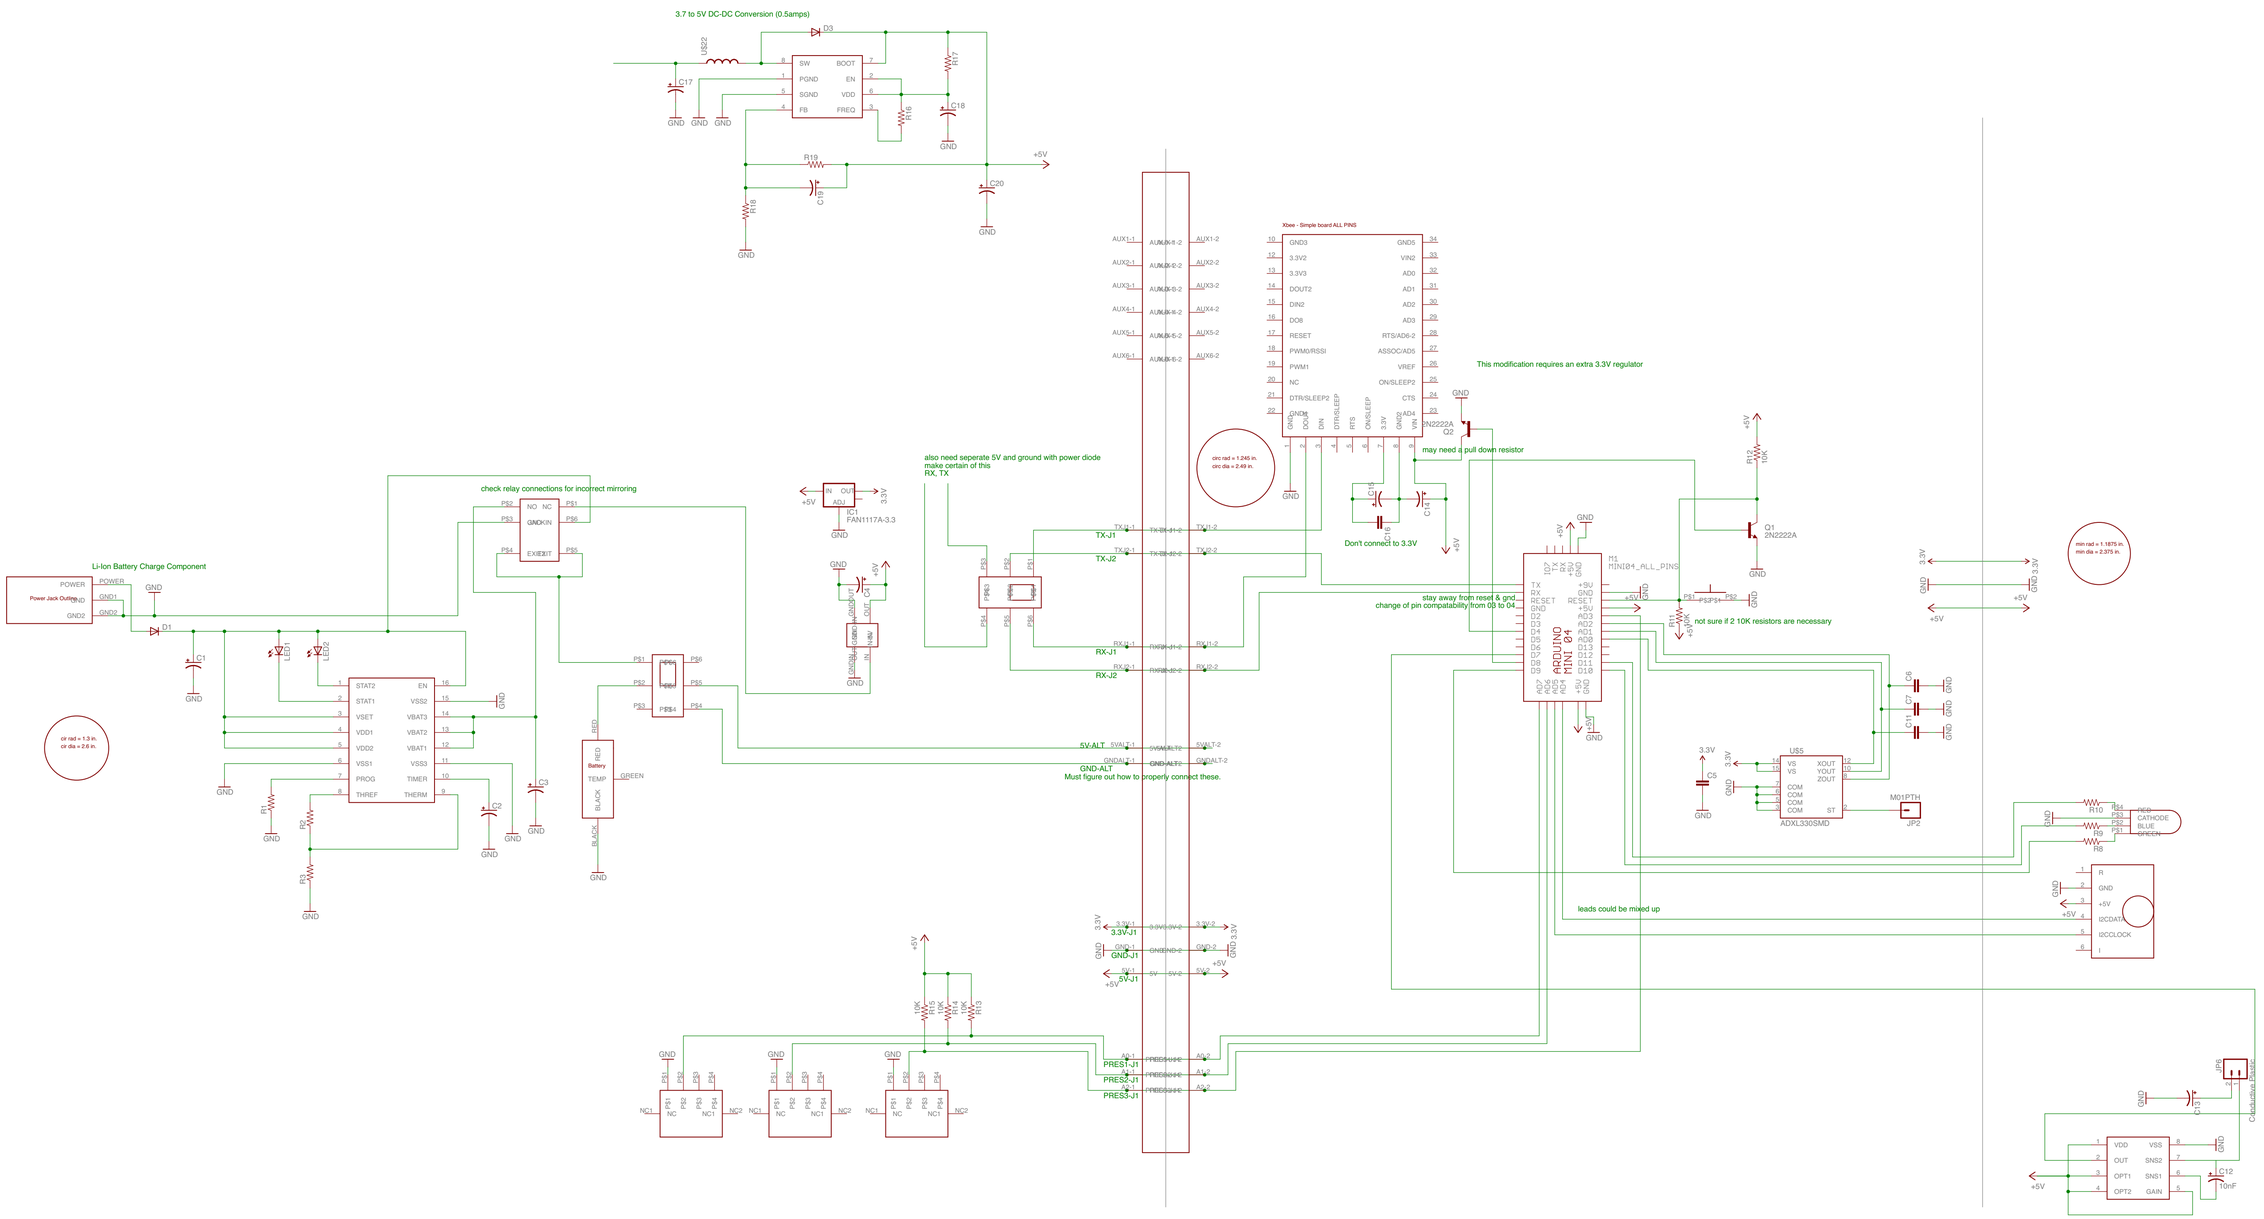
3.7 to 5V DC-DC Conversion (0.5amps)
Li-Ion Battery Charge Component
check relay connections for incorrect mirroring
also need seperate 5V and ground with power diode
make certain of this
RX, TX
Xbee - Simple board ALL PINS
This modification requires an extra 3.3V regulator
may need a pull down resistor
Don't connect to 3.3V
stay away from reset & gnd
change of pin compatability from 03 to 04
not sure if 2 10K resistors are necessary
leads could be mixed up
GND-ALT
Must figure out how to properly connect these.
circ rad = 1.245 in.
circ dia = 2.49 in.
min rad = 1.1875 in.
min dia = 2.375 in.
cir rad = 1.3 in.
cir dia = 2.6 in.
ARDUINO MINI 04
ADXL330SMD
I2CDATA
I2CCLOCK
Capacitive Pressure
